MEMORANDUM

To: File, 65-3617 & 65-8627
cc: Garrick Baxter
From: Scott King 
Date: July 8, 2003

Subject: Associated Earth Sciences, Inc. final recommendations

Subject: Review of Noe's diversion rate analysis for 65-03617 & 65-08627

Table 3. Primary soil types provided in Noe's report.

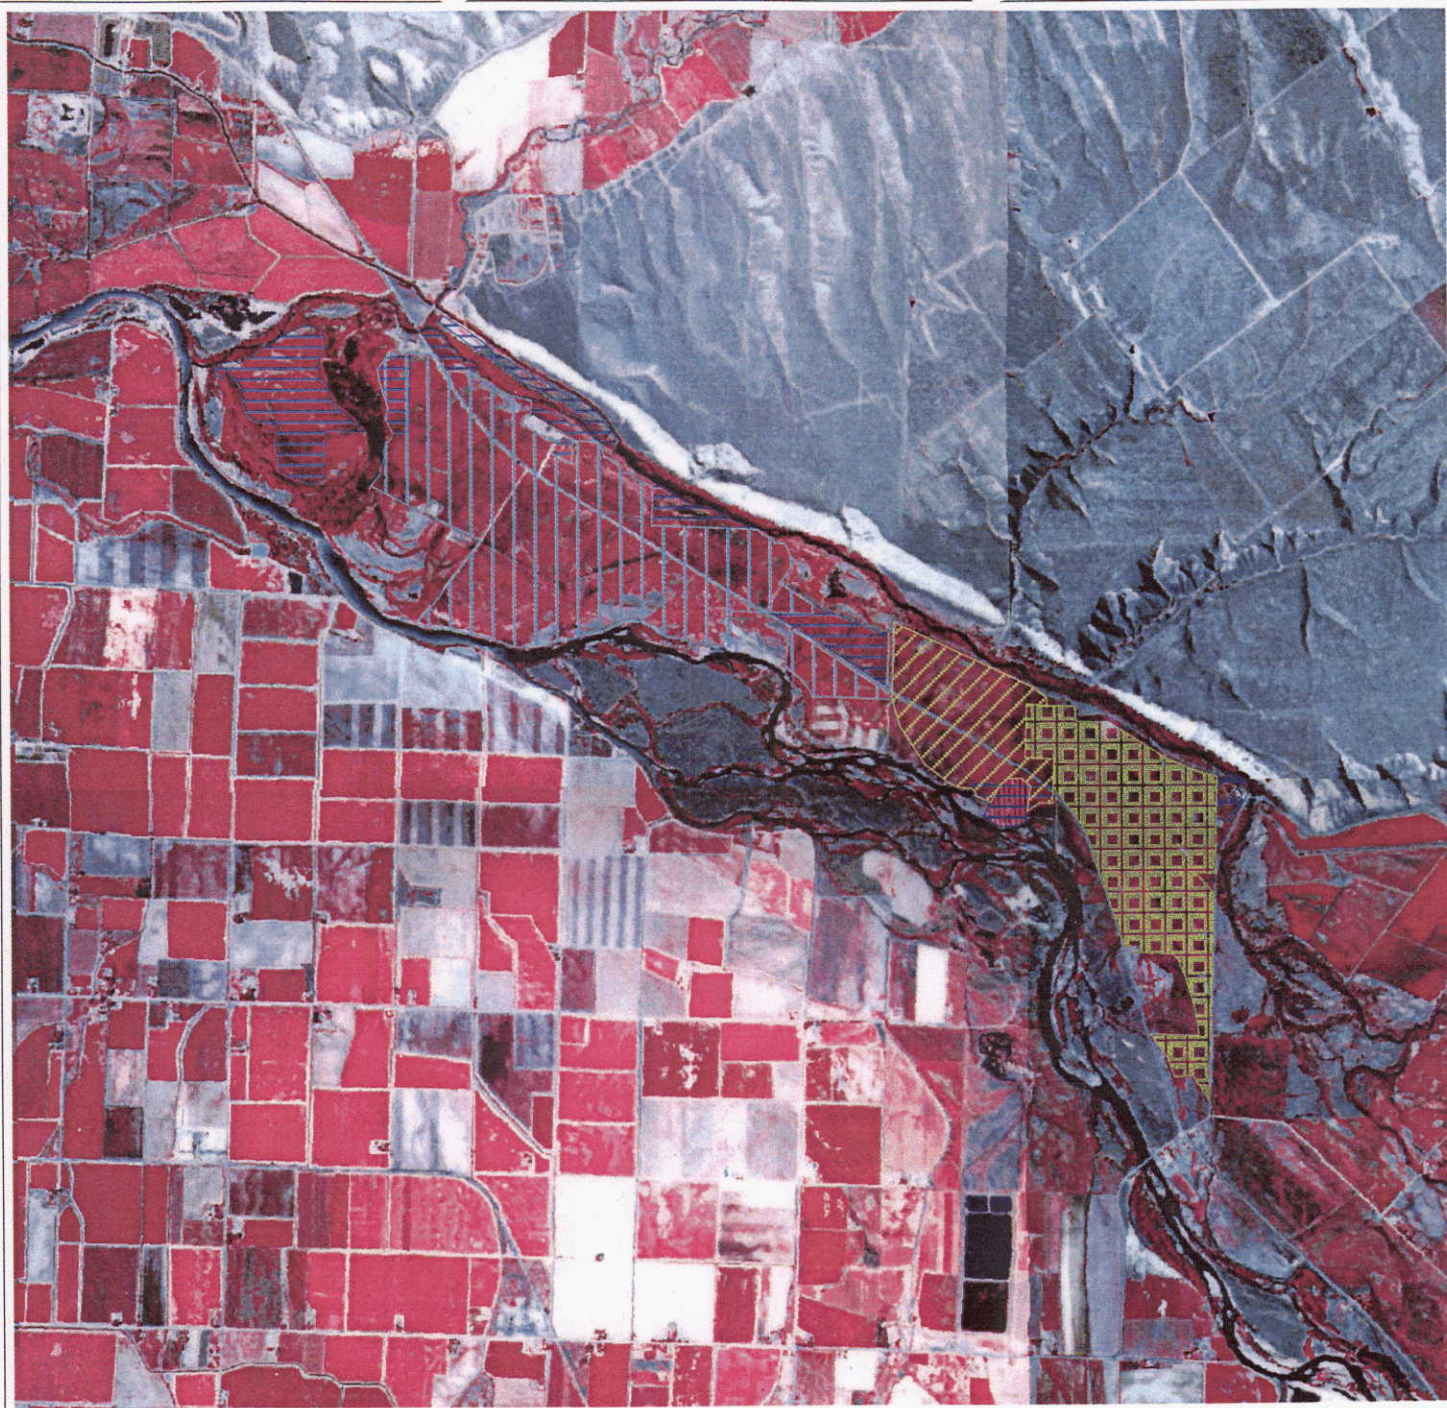
Detailed NRCS descriptions for three soil types are provided in Noe's report, and a summary is provided in Table 3. It appears these three are fairly representative of the other sandy loam soils found along the ditch length. The upper profiles are composed of sandy loams, while the lower profiles are sands and gravels. The sands and gravels will have higher permeability rates than sandy loams. However, there are several properties that combine to decrease the likely seepage rate. First, finer sediments from the upper profiles and in the diverted river water will likely settle along the ditch bottom, sealing the ditch over time and reducing infiltration rates. Based on the ditch dimensions provided by Noe in Table D, and also the low slope of the ditch, flow velocities in the ditch are likely low and thus the settling of sealing fines is supported. In addition, soil descriptions suggest a seasonal water table at depth from 1 to 4 feet. The high water table along the river bottom reduces the amount of loss from the ditch, and as suggested by Dan Nelson in his field exam for 65-7461, these ditches may actually gain water along their length.

Given the combination of these factors, I suggesting maintaining the seepage rate coefficient of 1.5 feet per day as used by Tuthill rather than the higher 2.5 feet per day value used by Noe as the lower value is likely most representative of field conditions. Application of the 1.5 feet/day seepage value to Noe's Worstell computations results in a total loss of 7.28 cfs, which is in close range to the total of 5.61 cfs determined using the Moritz formula. Also, if some of the more distant ditch segments beyond the field headgate are removed from the loss analysis, the total loss approaches 5.61 cfs.

The Worstell-type analysis performed by Noe provides results similar to those obtained by Tuthill's use of the Mortitz formula when similar seepage loss rate coefficients are applied. The seepage value of 2.5 feet per day in Noe is too high and does not appear representative of likely actual conditions; instead a seepage value of 1.5 feet per day as applied by Tuthill is recommended. A conveyance loss of 29.3% of the field headgate requirement should be applied to these rights because it is consistent with the loss previously determined and applied to other rights from the same diversion, and because it is consistent with Worstell loss analysis when the seepage coefficient is set at 1.5 feet per day.
